**Bulletin No: SB2004-01**  
**Category: STEINER**  
**Section:**  
**Index Ref: N/A**  
**Machine/s: ZTM Series**  
**Pages: 3**  
**Date: 3/12/04**

**SUBJECT: Kawasaki FH721V Remote Engine Air Filter**

### Heavy Duty Canister Air Filter Intake Pipe Modification (FH 601V, 641V, 680V, 721V)

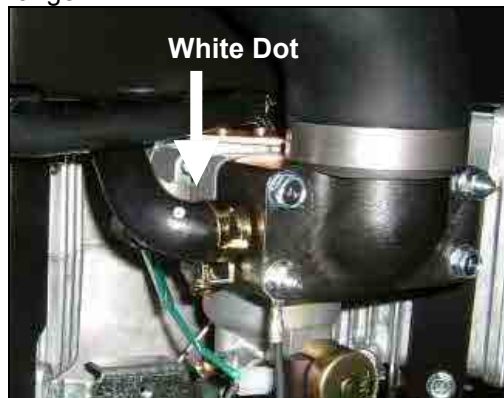
Sealing area between the intake pipe and carburetor is deformed.

Kawasaki has reinforced the intake pipe and added a bead on the gasket. Kawasaki has also reworked engines in inventory and initiated a Factory Directed Modification (FDM) campaign to repair eligible field units. Each machine manufacture will notify end users of this campaign and direct them to an authorized dealer for repair.

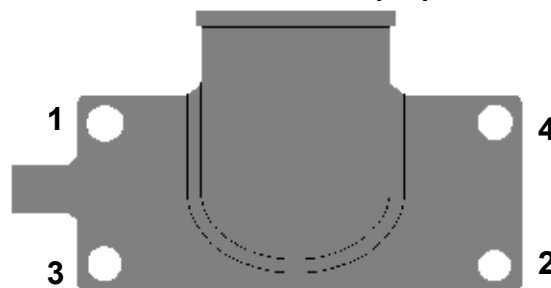
Repair all eligible units that have a heavy-duty canister air filter by installing a new reinforced plastic intake pipe and beaded gasket.

**Bolt Torque Specs: 4.3-5.7 ft/lbs.**

**Make sure to follow bolt torque pattern.**

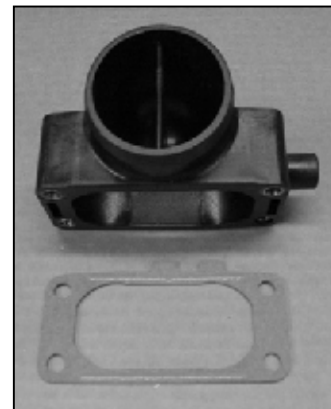
Kit contains intake pipe and beaded gasket.

Gasket should be installed with the tab down.
